Monthly Specification Update

Intel® Server Board S5520UR

Intel Order Number E69054-001

January 2011

Figure 1. Removing the Heatsink

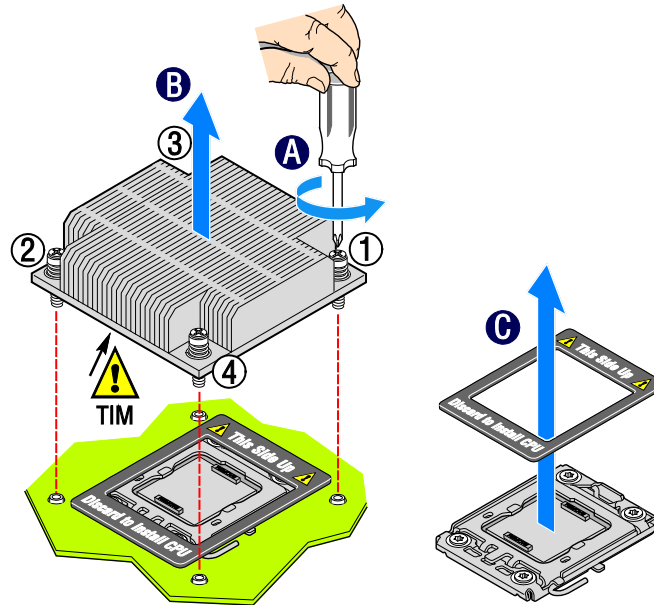
1. Proper Heatsink Installation and Removal Instructions are missing from Service Guide

Problem: The current documentation does not properly describe the installation and removal of the heatsink. Careful insertion and removal of the heatsink is required to prevent damage to the heatsink screws or backplate.

1. Loosen the four captive screws on the heatsink corners in a diagonal manner according to the numbers shown in figure 1 as follows:
 - Starting with the screw at location 1, loosen it by giving it **two rotations** in the anticlockwise direction and stop. (**IMPORTANT:** Do not fully loosen.)
 - Proceed to the screw at location 2 and loosen it by giving it two rotations and stop.
 - Loosen screws at locations 3 and 4 by giving each screw two rotations and then stop.
 - Repeat steps 1a through 1c by giving each screw two rotations each time until all screws are loosened.
2. Do one of the following:
 - If removing the heatsink for the first time, do the following:
 - i. Lift the heatsink from the board.
 - ii. Remove and discard the spacer (see letter “C” in figure 1).
